Project Name : Bilsham Road, Yapton

Job No : 19-326

Note Title : Drainage Strategy Addendum No. 1

Job Title			
BILSHAM ROAD, YAPTON			
Drawing Title			
PRELIMINARY ENGINEERING LAYOUT. SHEET 2 OF 2			
Client			
BILSHAM ROAD DEVELOPMENT LLP			
Scale	Date	Designed	NA
1:500 @A0	FEB 20		
Drawn	Checked	Approved	GG
LS	JH		
Job No	Drawing No	Rev	
19-326	19-326/010	K

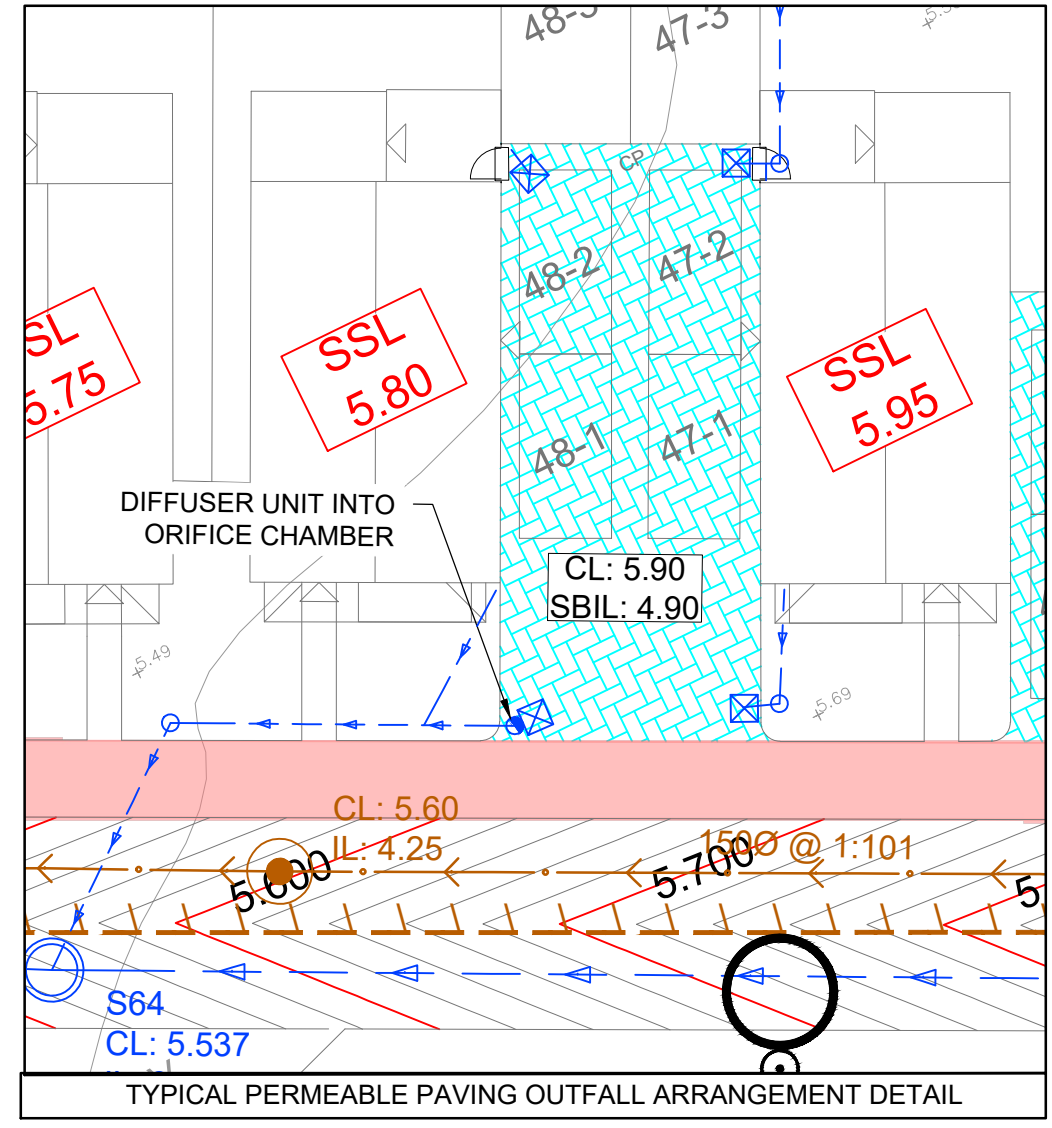
“Groundwater monitoring results must be provided and should be overlaid on detailed drainage layout drawings.”

“All pipes must be labelled with diameters and falls.”

“Manhole invert and cover levels must be provided.”

“Note to be added to drawing to state that watercourses will be cleared of vegetation and silt as part of works. These works must be completed near the beginning of construction to ensure the free flow of water.”

2.1.3 The results of groundwater monitoring are provided in **Drawings 19-326/009 and 19-326/010** in **Appendix B**.

2.1.4 The diameters of the proposed pipes were included in the submitted drainage strategy drawings. The falls have been added to show the gradient of the pipes, and are shown in **Appendix B**.

2.1.5 The invert and cover levels of the proposed manholes are shown in **Appendix B**.

2.1.24 A note detailing the works to the watercourses has been added to the drawings in **Appendix B**.
